Hillingdon

Outline Fire Strategy – Rev E

OF-OFS-3671-01-E

Appendix A – Drawing Comments

4 Building 5 - Fifth to Tenth Floor Plan
1 : 200

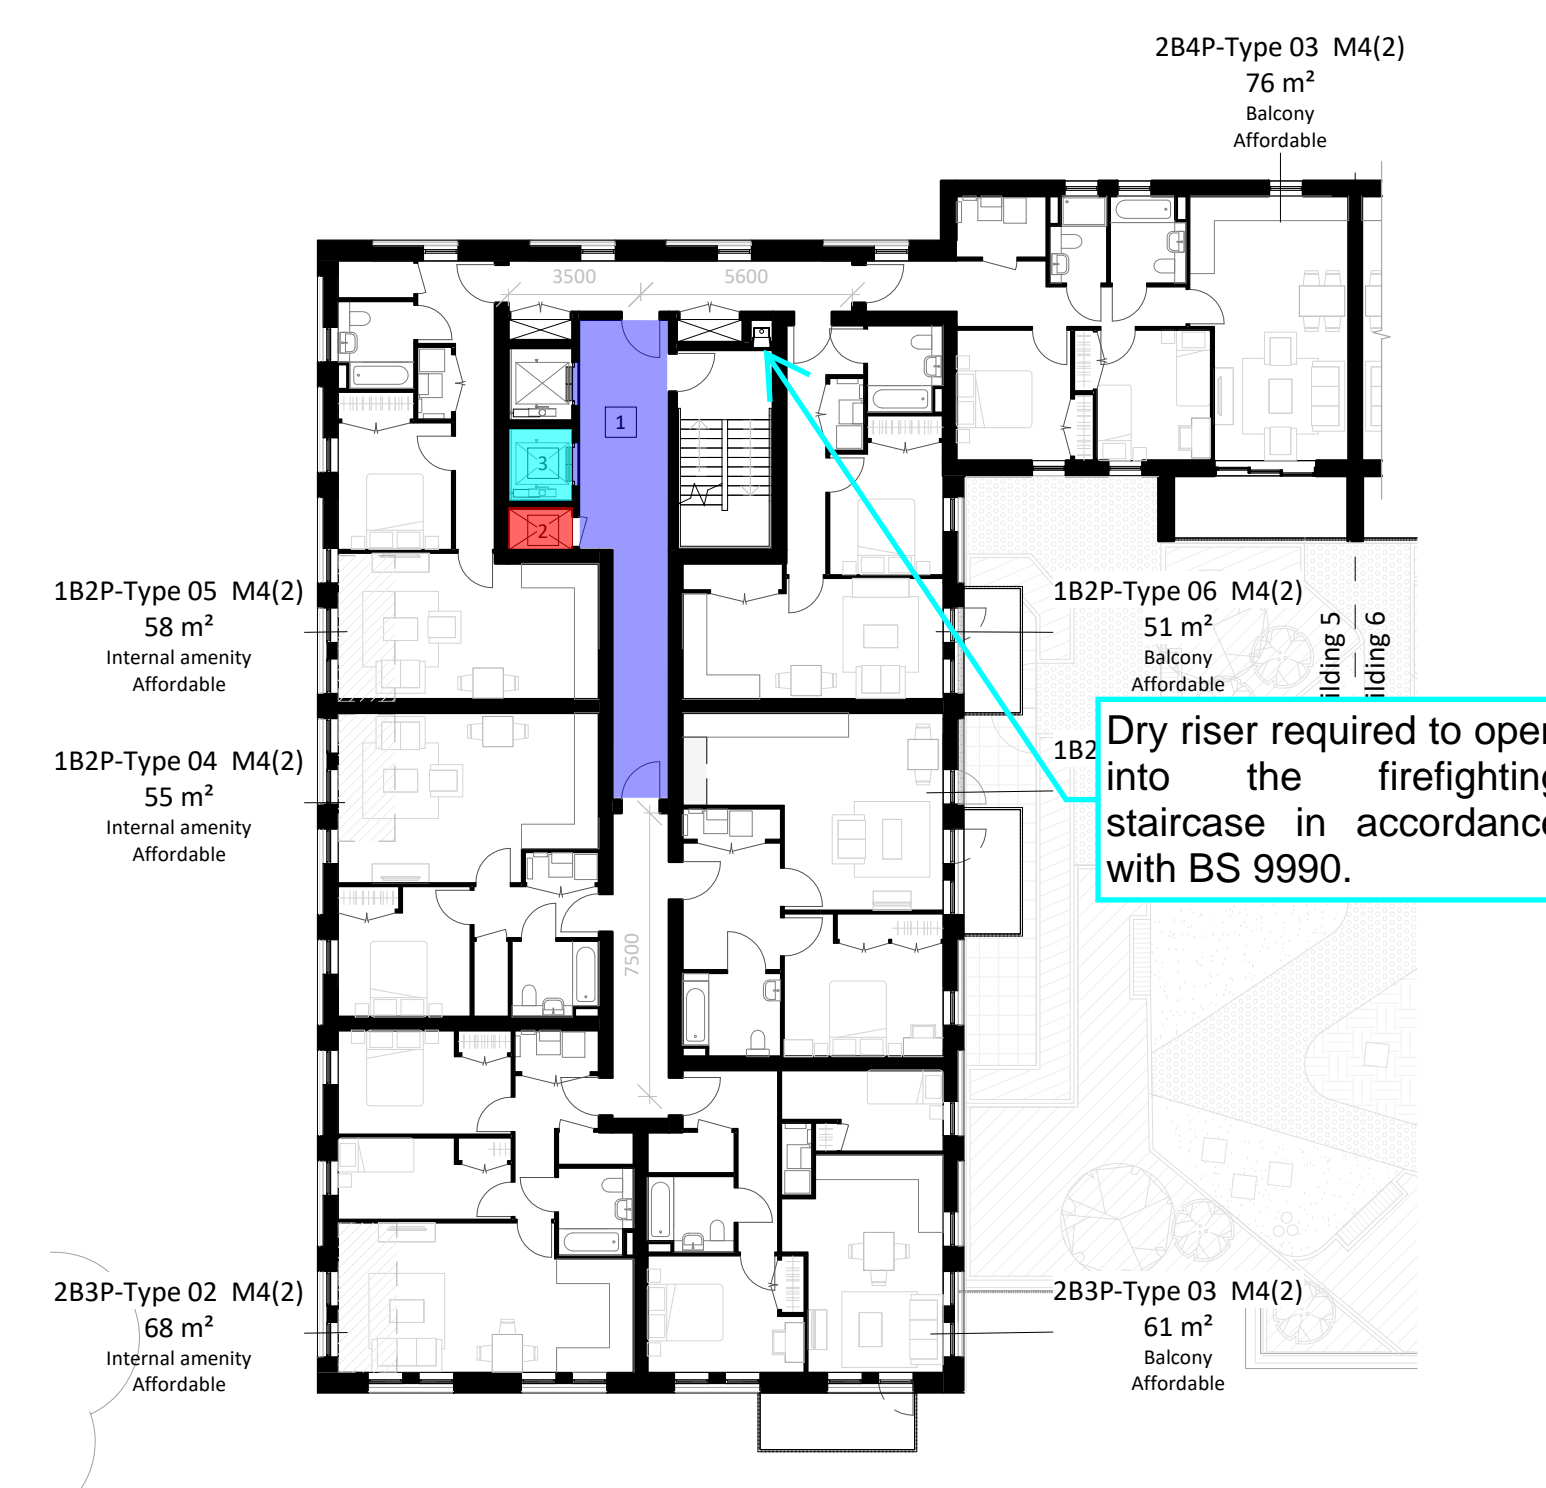
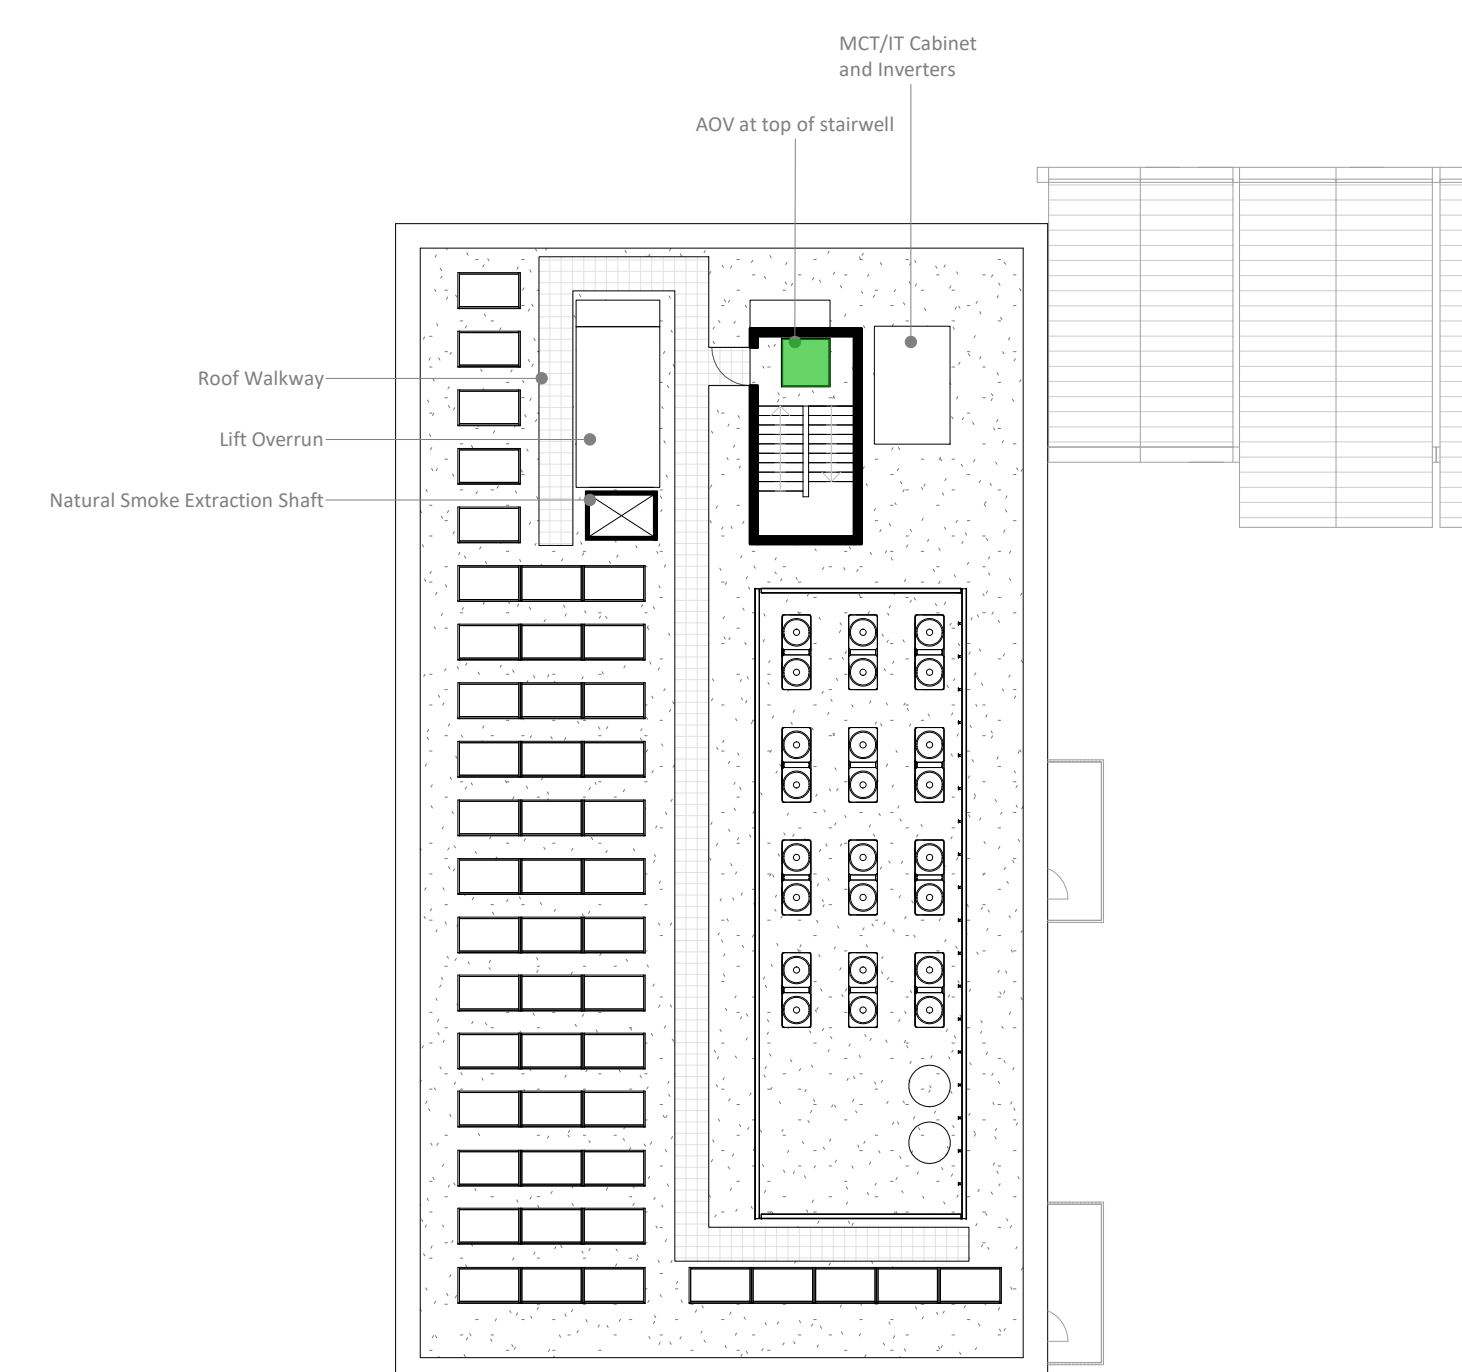
To be noted, if the service riser is to only contain water services or metal ventilation ductwork from the ground floor, it is considered a limited fire hazard. As such, this riser shaft may be located in the staircase lobby.

As Building 5 exceeds 30m in height from lowest external level to topmost occupied floor, a minimum Category 2 sprinkler system with a discharge density in accordance with Table 2 - Footnote b of BS 9251, is to be provided throughout the building.

To be noted, the government have stated from May 2020, all new building's over 11m in height are required to be provided with sprinklers, see Section 9.
